**Re: FortisBC Energy Inc. (FEI)**

**Application for a Certificate of Public Convenience and Necessity (CPCN) for the  
Tilbury Liquefied Natural Gas Storage Expansion (TLSE) Project (Application)**

**Response to the British Columbia Utilities Commission (BCUC) Information  
Request (IR) No. 6**

**Figure 1: Comparison of Design Load Profile 2019/20 and 2020/21**

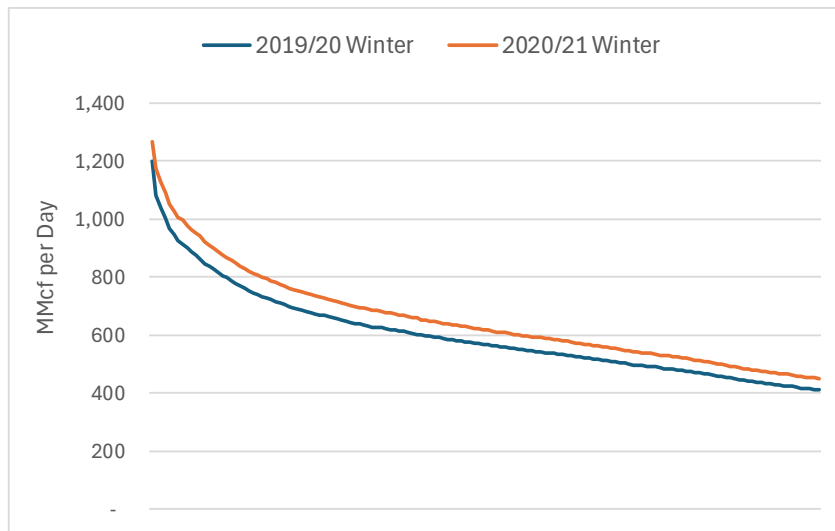
33  
34            143.3 Please elaborate on how the return of Transportation customers to Core customers  
35            (i.e., RS 23 returning to RS 3) has impacted RS 3 winter and peak day demand.  
36            In your response, please include a discussion on the typical load profiles for such  
37            customers.

Customer migration occurs constantly, and the impact to ACP load is blended with the organic customer growth and reflected in the annual update to the ACP load forecast. FEI saw the largest migration of Transportation customers in gas year 2020/21 in which ACP winter design load increased by 8 Bcf (9 percent) compared to the previous year. Peak day demand also increased by 65 MMcf/d (or 5 percent) in one year. Figure 1 below compares the design load profile of the 2019/20 and 2020/21 winter season (November to March) and shows the impact of a significant number of Transportation customers returning to being Core customers.

(in MMcf)	2019/20	2020/21	% Increase
<b>Design Winter Demand</b>	91,357	99,594	9%
<b>Peak Day</b>	1,200	1,265	5%

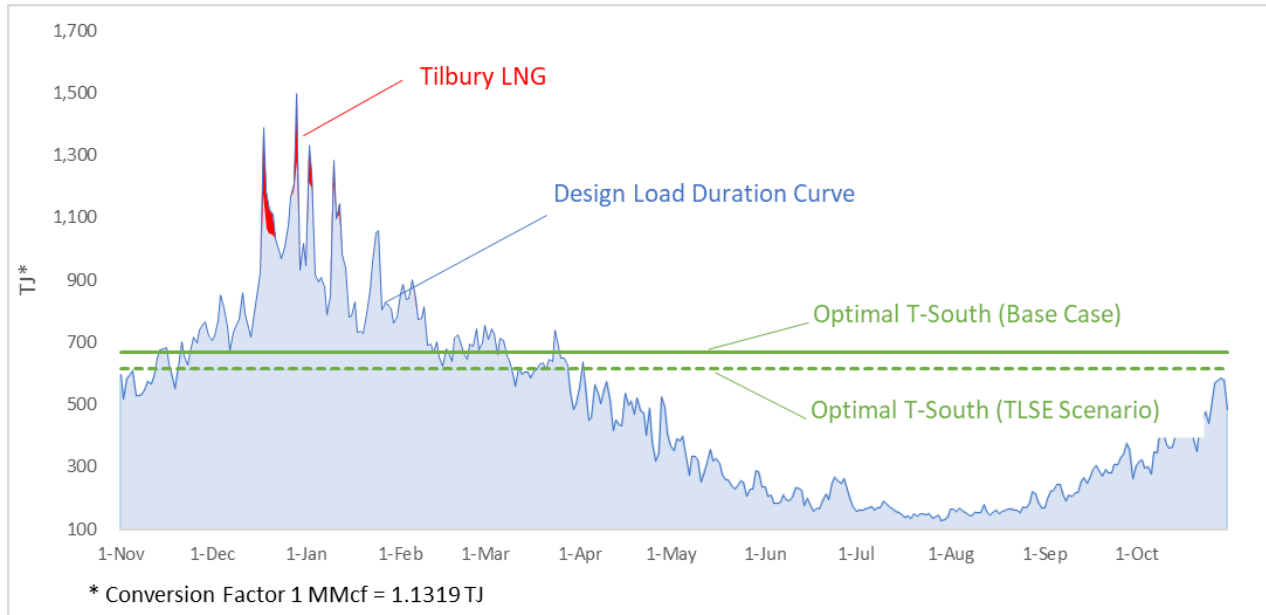
143.4 Please provide annotated load duration curves for FEI's design year, which illustrate FEI's possible gas supply portfolio assuming:

As discussed in the response to BCUC IR5 118.1, the annual design load and peak day demand have increased significantly during the past 10 years, but FEI has not been able to add any peaking assets to the ACP resource portfolio (except a temporary increase of Mist storage until 2026/27 before a significant amount of Mist storage is recalled). To meet the increased demand, FEI has been relying on:

- 1) Pipeline capacity to meet all incremental load, including peak day load. In an unconstrained market, FEI would add a mix of resources including pipeline, storage and peaking assets (such as LNG storage) so that its gas supply portfolio remains cost effective. However, because regional resources are fully contracted, the only resource FEI had access to at reasonable costs was T-South capacity.
- 2) Peaking call options, which are short-term commercial transactions for FEI to receive peaking gas at the East Kootenay interconnect (EKE) when additional supply is needed on cold days.

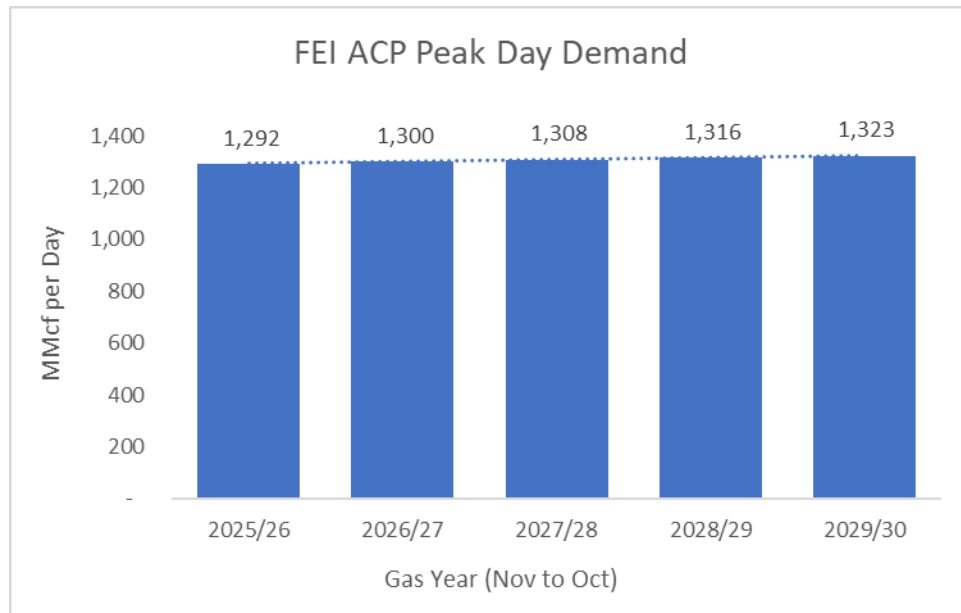
30                    144.1 Please provide a graph showing the future peak demand forecast that would be  
31                    used for the purposes of supply planning, and discuss the observed trend over  
32                    time.

35                    FEI develops a peak day forecast for the purposes of supply planning as part of its ACP filing.  
36                    The ACP focuses on the upcoming gas year for supply plan contracting and provides an outlook

- 1 for resource requirements in the next five years. The figure below provides the most recent peak  
 2 day forecast used for 2025/26 ACP gas supply planning.

3  
 4 As shown in the figure above, peak day demand is forecast to increase by 8 MMcf/d each year in  
 5 the next five years (2025-2030). The ACP load forecast is developed based on actual daily  
 6 consumption in the past three years with a moderate projection of customer additions for the next  
 7 five years, based on the principle that the most recent past is the best predictor of the near-term  
 8 future. FEI validated the forecast with the actual consumption in the past few years, as the model  
 9 used to develop the ACP load forecast has provided accurate projections compared to actuals  
 10 during recent winter events that have approached the design weather conditions used in the  
 11 model.

**Figure 4-7: Annual Cost (Post Mitigation) of Using Expanded Regional Infrastructure to Supply Equivalent of 1 Bcf, 200 MMcf/d**

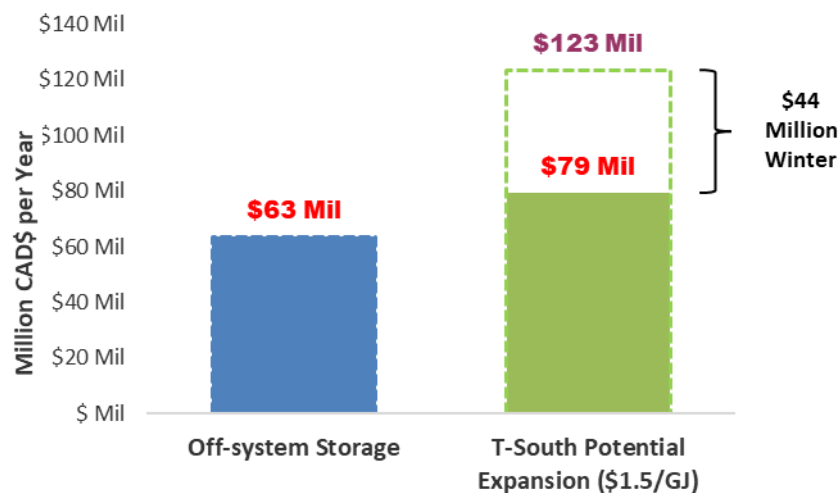
FEI also clarifies the mitigation revenue referenced in the preamble:

- The responses to BCUC IR5 131.5 and 131.6 relate to a scenario in which FEI is holding a peaking supply of 1 Bcf paired with 200 MMcf/d from a regional pipeline expansion in the absence of the TLSE Project. The cost of this scenario was illustrated in Figure 4-7 of the Supplemental Evidence (reproduced below). As discussed on page 137 of the Supplemental Evidence, FEI assumed that it would continue to seek mitigation for its gas supply costs by selling underutilized pipeline capacity into the market in non-peak times, thus reducing the total annual cost from \$123 million to \$79 million after mitigation.

If FEI is able to generate more mitigation revenue, then it would reduce the annual gas supply costs under the scenario of holding capacity from a regional pipeline expansion (i.e., reduce the \$79 million in Figure 4-7), which in turn reduces the assumed benefits (i.e., avoided cost) of the TLSE Project. In other words, if the annual gas supply cost, net of mitigation for holding pipeline capacity from a regional pipeline expansion, is reduced
